Final Approval - PUD 58
Emerald Heights

ORDINANCE NO. 1454

AN ORDINANCE OF THE CITY OF REDMOND, WASHINGTON,
GRANTING FINAL PLANNED UNIT DEVELOPMENT APPROVAL
FOR EMERALD HEIGHTS PUD NO. 48.

EMERALD HEIGHTS SDP--87--9/PUD #48

ATTACHMENT 2

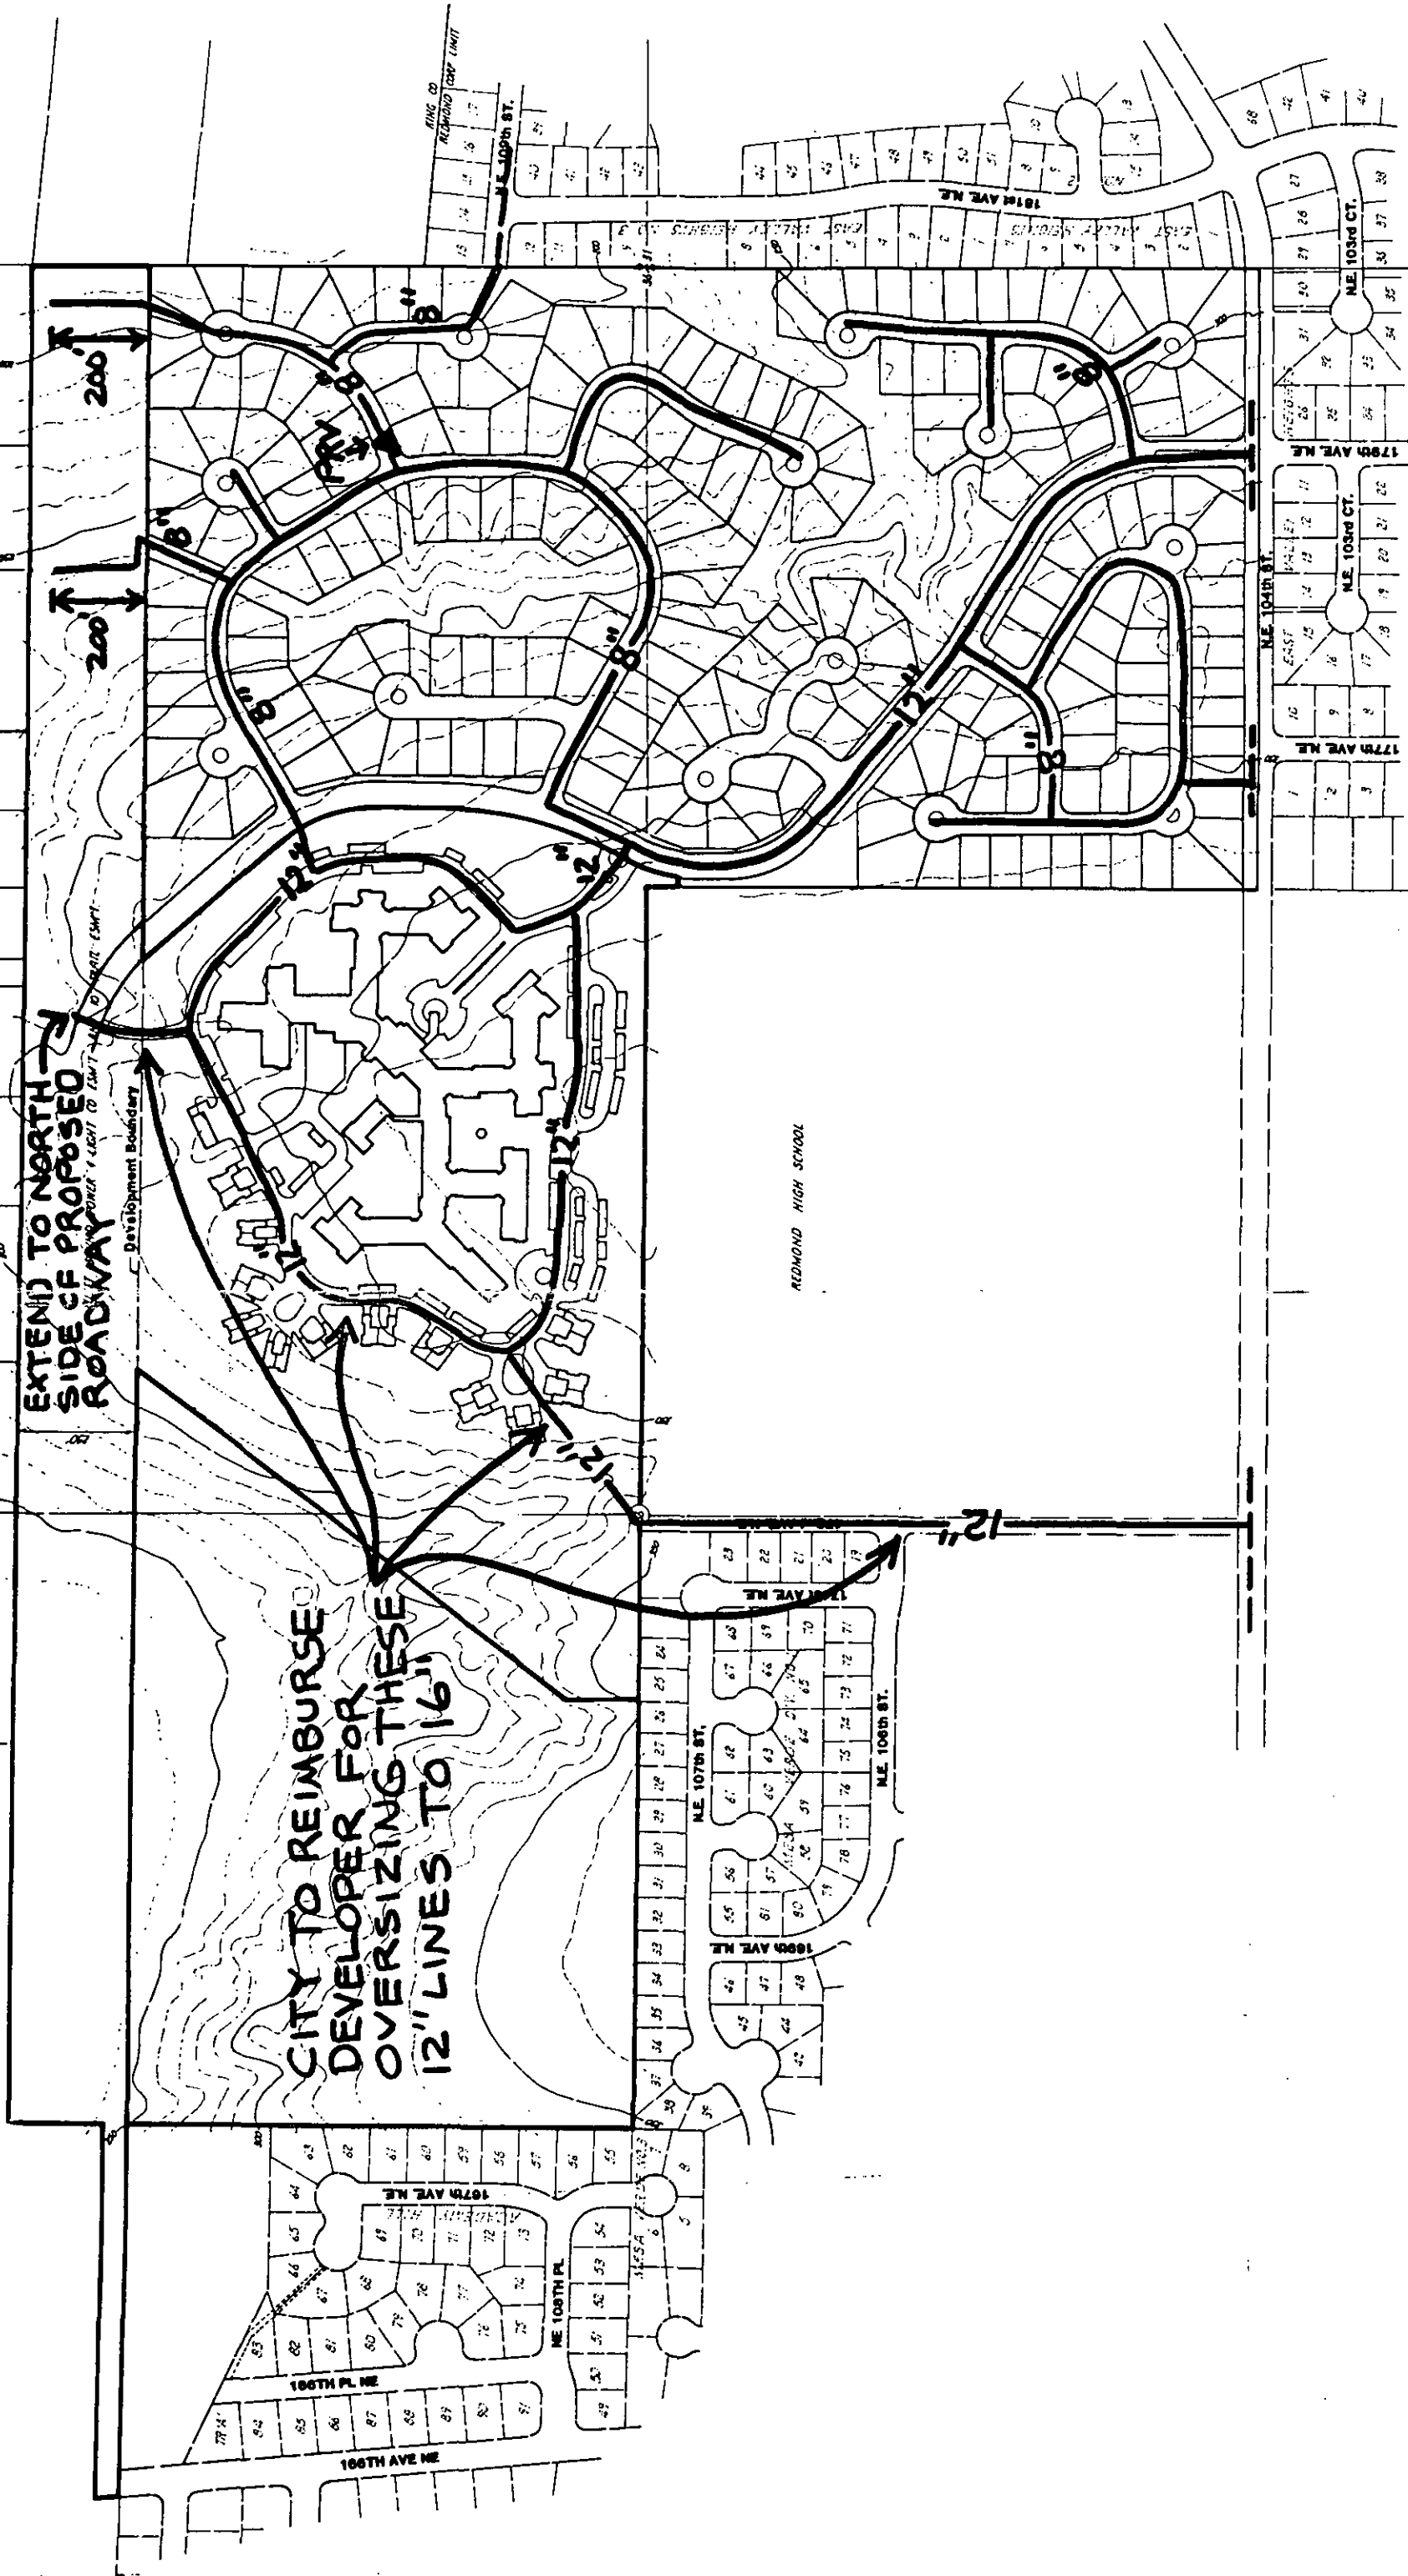
- A. Water service will require a developer extension of the City of Redmond water system. The water system extension to serve the site shall be developed in conjunction with the water system for the proposed plat of Abbey Road and shall conform to the layout shown in Attachment 2.

- B. The developer shall construct a 16-inch main in 172nd Avenue and along the western road of the project as shown in Attachment 2. The applicant will be reimbursed by the City the incremental cost increase for oversizing this 16-inch main from a 12-inch main. The incremental cost for oversizing shall be \$15 per foot. If, at the time of construction, either the City or the Applicant believes that the oversizing cost of \$15.00 per lineal foot is incorrect, either party may elect to request that the incremental cost increase of oversizing be determined by comparative bids submitted by the contractor at the time of construction.

ATTACHMENT 3

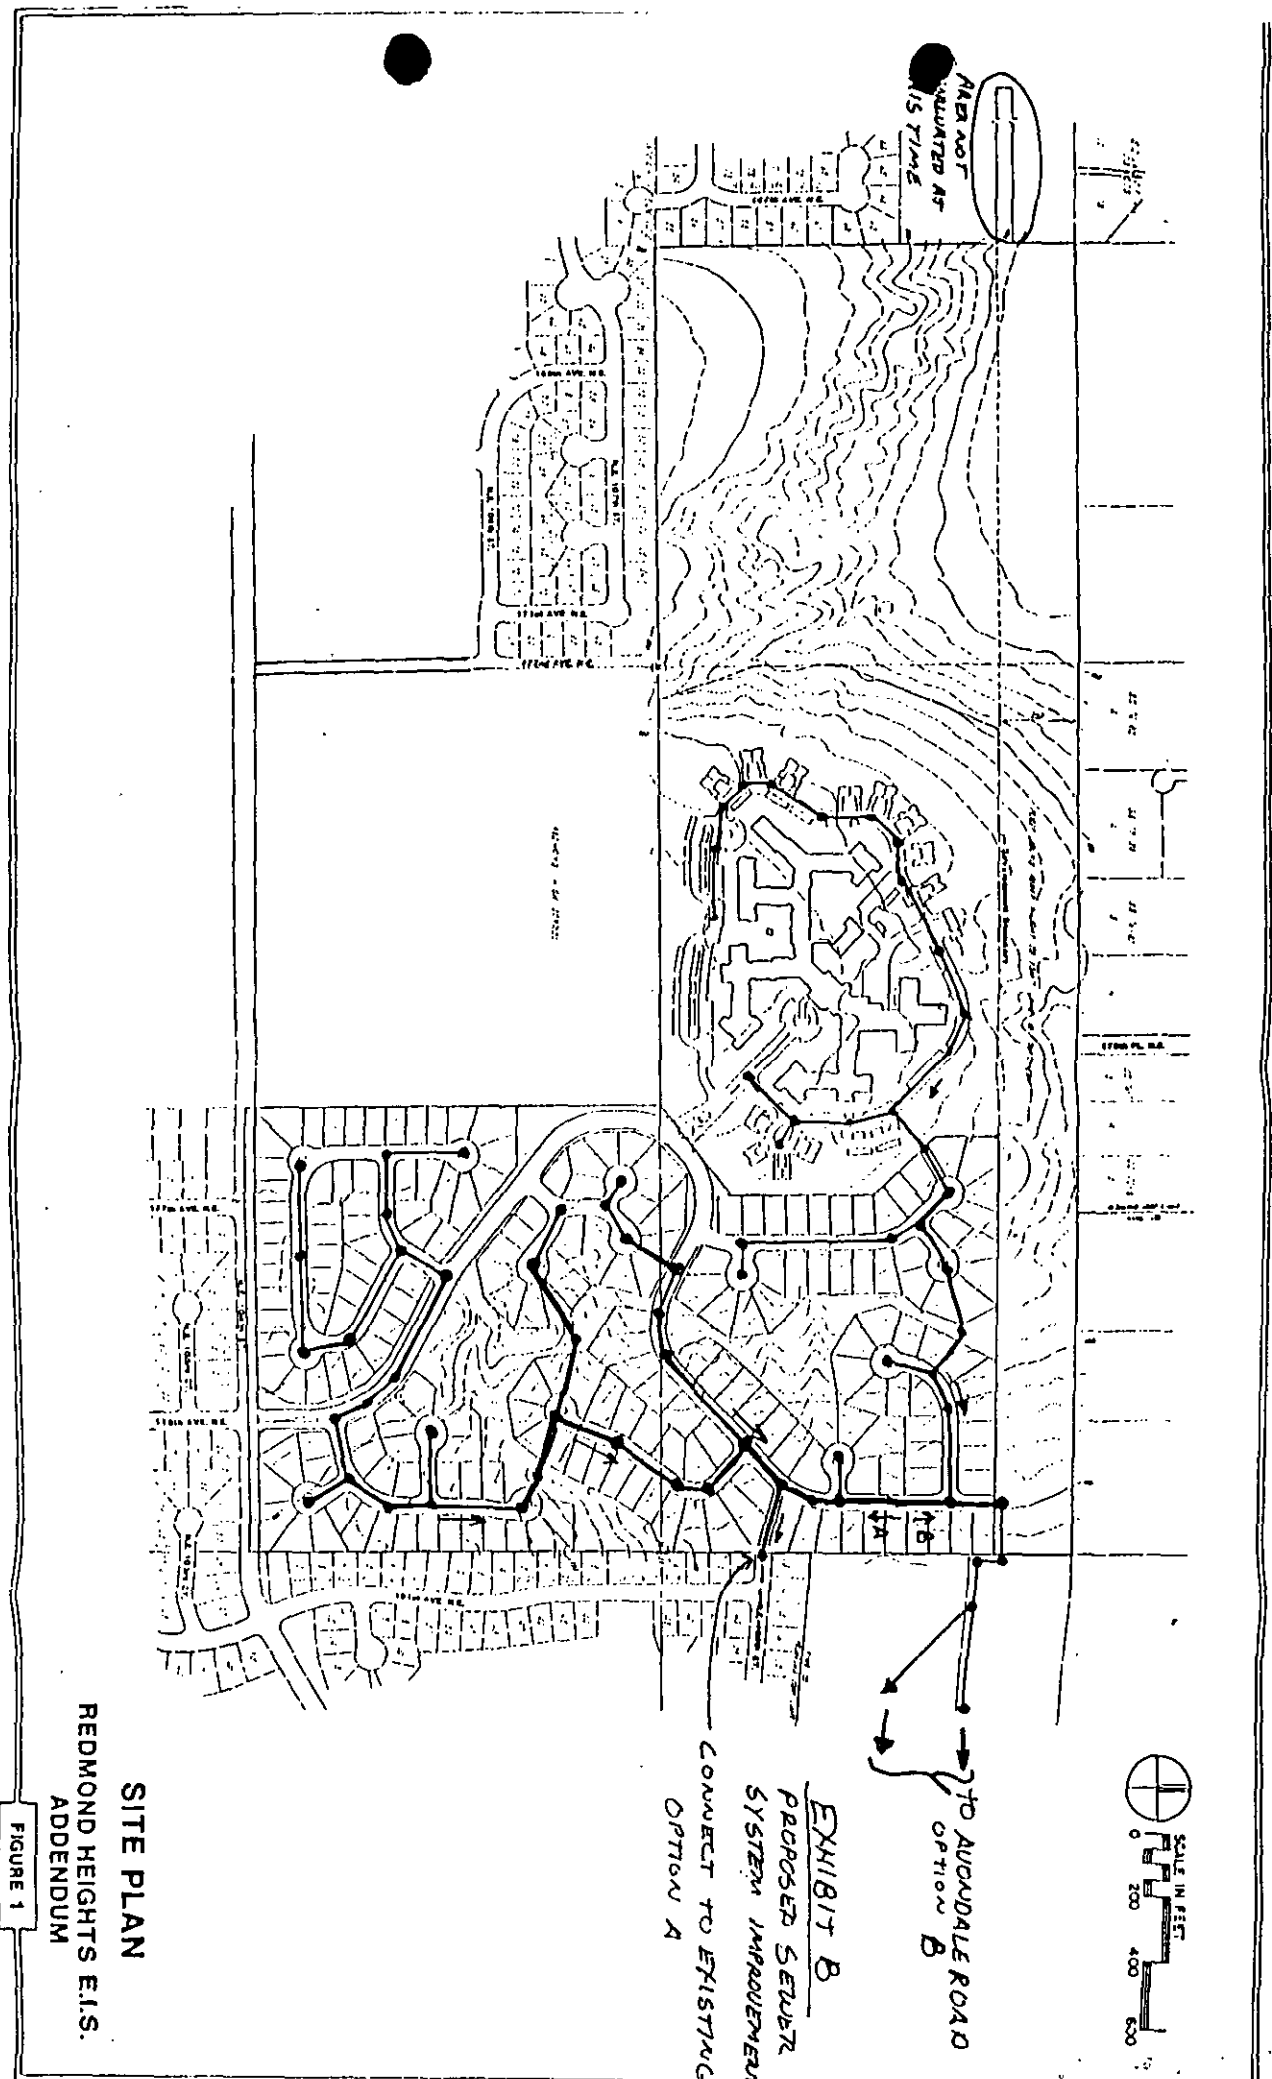
- A. Sewer service will require a developer extension of the City of Redmond sewer system. This extension shall generally conform to the proposed layout shown on and described in Attachment 3, which was a part of Exhibit L, admitted at the 6-6-88 public hearing before the Hearing Examiner with modifications as needed for the proposed street layout. Sewer service will not be available to the PUD until completion of the off-site sewer improvements proposed by the City on Avondale Road.
